# Wind Noise From Antenna

Toyota Supports  
 ASE Certification

| YEAR(S)     | MODEL(S) | ADDITIONAL INFORMATION |
|-------------|----------|------------------------|
| 2009 – 2010 | Matrix   |                        |

**Figure 2.**

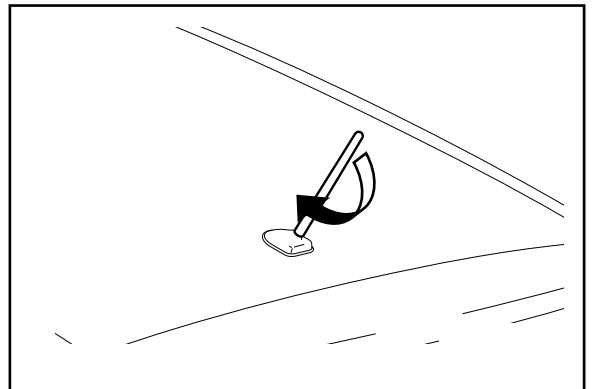
Some customers may complain about wind noise at highway speeds from the rear of the vehicle where the antenna is mounted. A modified antenna has been made available to improve this condition.

2. Install NEW roof antenna pole by turning it clockwise.
